**Re: Development Application – Lot 401, 49 McKenna Drive, Cardup – Retrospective Cleanfill**

**Re: Lot 401 McKenna Drive, Cardup – Retrospective Cleanfill**

**Lot 401  
McKenna Drive  
CARDUP**

Attachment 10.1.1.3

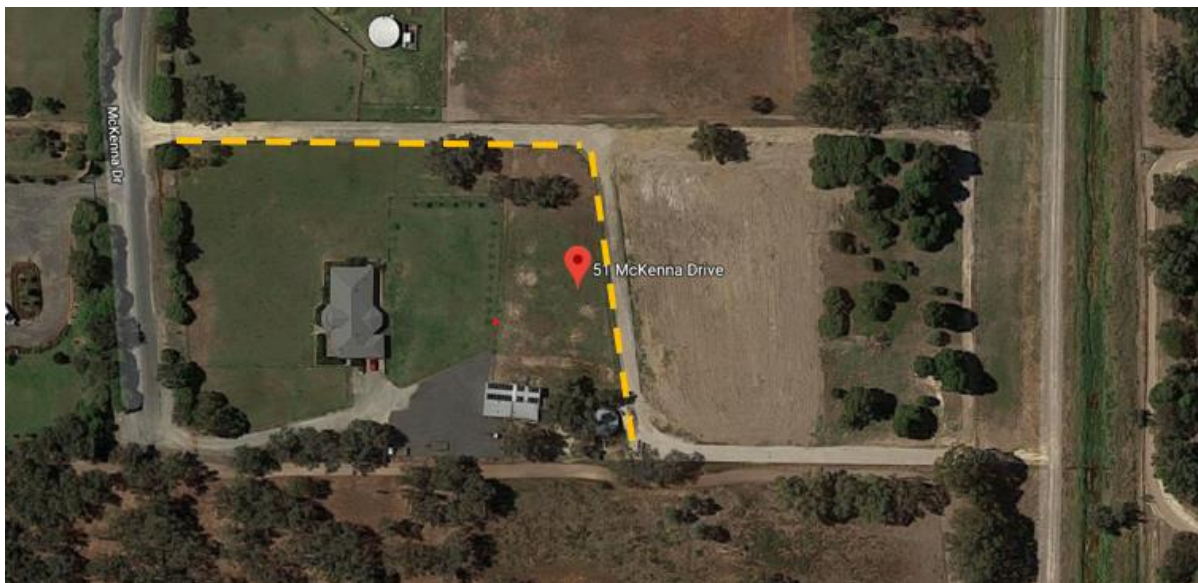
We moved into 51 McKenna Drive on 15 March 2019 and at the time of purchasing the property, we were aware that the property would be subject to some flooding during winter. On 4 July we had a substantial amount of rain which resulted in extensive flooding on our property. In my opinion, this flooding was made worse due to the amount of fill that has been placed on the applicant's driveway to the north of our property and to the east (rear). I have attached photos taken on 4 July of the flooding along the fence line which separates our property and 49 McKenna Drive.

The water run off from this driveway is currently being removed via a drain that has been dug along the fence line on our property. The runoff on the other side of the driveway is also causing flooding on the neighbouring property of 43 McKenna Drive. There has been no attempt made by the applicant install any type of drainage system on his property to negate flooding issues to neighbouring properties. I did give consideration to digging a drain along our fence line at the rear of our property to alleviate the runoff problem but I don't believe this should be our responsibility.

If possible, we would ask that the applicant be made responsible for installing separate drainage on his property, particularly along the eastern and northern boundaries of the fence line adjoining our properties to alleviate excess run off (Attachment A). This drain would also need to encompass the run off that is occurring from the fill area that has been placed behind the applicant's proposed shed site and next to our rain water tank. There is evidence of runoff from the driveway area entering our property around the rain water tank.
